Access Compliance Report

Public Rights-of-Way

Intersection ID: 10030167	Main Street: LATROBE_DR	Cross Street: N/A	Location: E
ADA ID: 7977D1B95652	Ramp Type: PerpDiag	Initial Pass/Fail: Fail	Overall Compliance: No
		Severity Score: 37.5

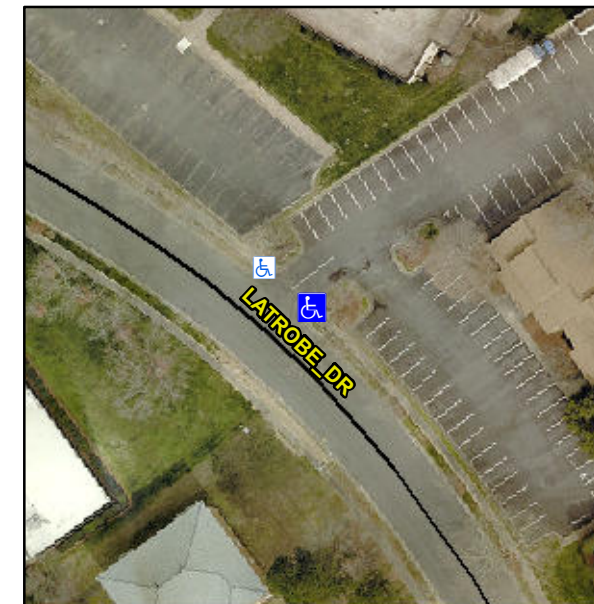
Not Found, R304.2.2, R304.5.3

Compliance	Description	Data	Compliance	Description	Data
N/A	Ramp Length (in)	48.0	No	Ramp Slope (%)	13.8
Yes	Ramp Width (in)	48.0	No	Ramp XSlope (%)	5.9
N/A	Flare Type LT	N/A	N/A	Flare Type RT	N/A
N/A	Flare Slope LT (%)	N/A	N/A	Flare Slope RT (%)	N/A
N/A	Flare Traversable LT?	N/A	N/A	Flare Traversable RT?	N/A
N/A	Landing Length (in)	N/A	N/A	DWS Provided?	N/A
N/A	Landing Width (in)	N/A	N/A	DWS Contrast?	N/A
N/A	Landing Slope (%)	N/A	N/A	DWS Length (in)	N/A
N/A	Landing X Slope (%)	N/A	N/A	DWS Full Width?	N/A
N/A	Landing Curb? (Y/N)	N/A	N/A	DWS Offset (in)	N/A
N/A	Shared Landing?	N/A			
N/A	Gutter Ponding?	N/A	N/A	Gutter Slope (%)	N/A
N/A	Gutter Lip Ht (in)	N/A	N/A	Gutter X Slope (%)	N/A
N/A	Painted X Walk1?	No	N/A	Painted X Walk2?	No
	X Walk 1 Direction	To NW		X Walk 2 Direction	To SW
N/A	X Walk 1 Width (in)	N/A	N/A	X Walk 2 Width (in)	N/A
	X Walk 1 Slope (%)	3.2		X Walk 2 Slope (%)	7.6
	X Walk 1 X Slope (%)	6.6		X Walk 2 X Slope (%)	1.8

Remove & Replace Curb Ramp With Two New Directional Ramps or Equivalent.
